Item ID: D412-664-203TRN

Item Name: Crosstube Turning Detail

DRAWING NO. D412-664-243	TITLE CROSSTUBE ASS'Y (412 HI AFT)	REV. E	DART AEROSPACE LTD ENGINEERING ORDER		D.E.O. NO. D412-664-243-E-2	SHEET NO. SHEET 1 OF 1	SCALE NTS
DRAWN 97	CHECKED ASS	MFG. APPR. RE	APPROVED MP		DE APPR. #		
DATE 11.09.07	DATE 11.09.19	DATE 11.09.19	DATE 11.09.19		DATE 11.09.19

DRAWING NO. D412-664-243	TITLE CROSSTUBE ASSEMBLY (412 HI AFT)	REV. E	DART AEROSPACE LTD ENGINEERING ORDER		D.E.O. NO. D412-664-243-E-4	SHEET NO. SHEET 1 OF 3	SCALE NTS
DRAWN 90	CHECKED A	MFG. APPR. A	APPROVED MP		DE APPR. MP		
DATE 12.08.21	DATE 12.08.30	DATE 12.08.30	DATE 12/8/30		DATE 12.08.30

**D412-664-243
ASSEMBLY DETAIL**

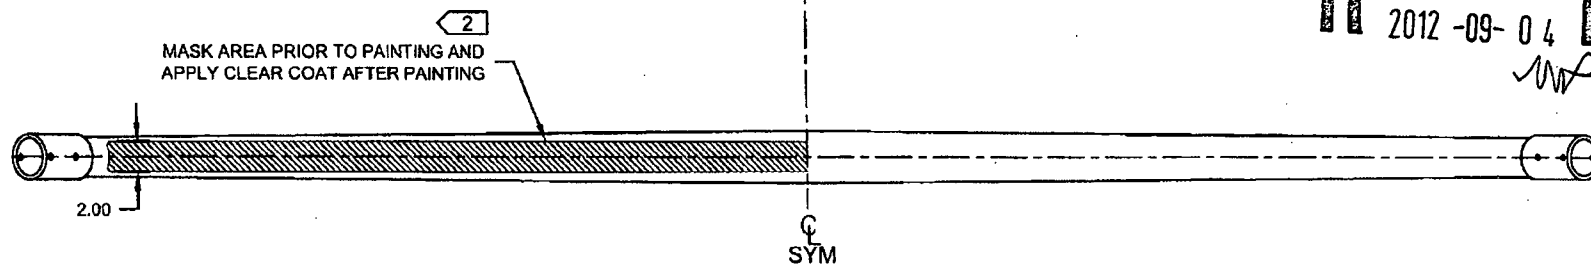
REMOVED ABRASION STRIP IN FAVOR OF A THIN LAYER OF PROSEAL 890. UPDATE INSTALLATION OF CHAFING SHIELDS AND REDUCE TORQUE TO 40-50 IN-LBS. THIS ENGINEERING ORDER SUPERCEDES DEO D412-664-243-E-1.

D3189-1 CHAFING SHIELD (1, INSTALLED OVER PROSEAL 890)
MS21920-28 CLAMP, 2X
2 PL

SECTION A-A
CHAFING SHIELD DETAIL
VIEW ROTATED, NOT TO SCALE

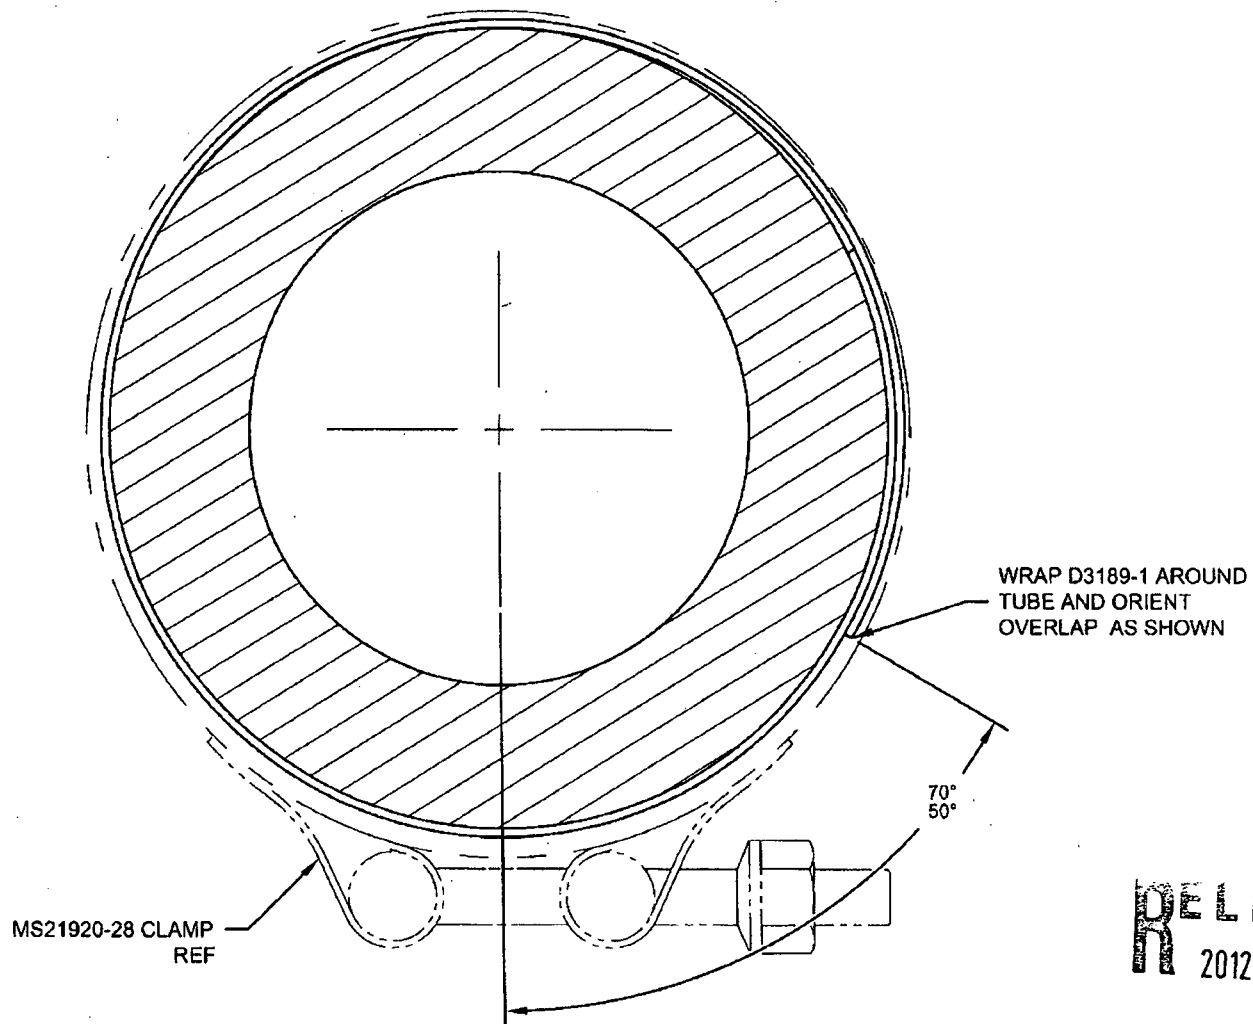
- 2) FINISH: CHEMICAL CONVERSION COAT PER DART QSI 005 4.1
PRIME INSIDE AND OUTSIDE PER DART QSI 005 4.2
MASK UNDERSIDE OF CROSSTUBE AS SHOWN (HATCHED AREA)
PAINT OUTSIDE PER DART QSI 005 4.2
AFTER PAINTING, APPLY CLEAR COAT ON HATCHED AREA
- 14) APPLY A THIN COAT OF PROSEAL 890 ON INSIDE CONCAVE SURFACE OF D3189-1 CHAFING SHIELD AND LET CURE PER MANUFACTURER'S INSTRUCTIONS. INSTALL PROSEALED D3189-1 CHAFING SHIELD ONTO CROSSTUBE BY APPLYING A THIN COAT OF PROSEAL 890 ONTO CROSSTUBE. BE SURE TO ELIMINATE ANY AIR GAPS.
- 16) TORQUE CLAMPS ON D2896-1 SUPPORT 80 TO 100 IN-LB. **TORQUE CLAMPS ON D3189-1 CHAFING SHIELD 40 TO 50 IN-LB.** ENSURE AT LEAST 1.5 THREADS SHOWING IN SAFETY AND THAT NUT HAS NOT BOTTOMED-OUT AFTER TORQUING.
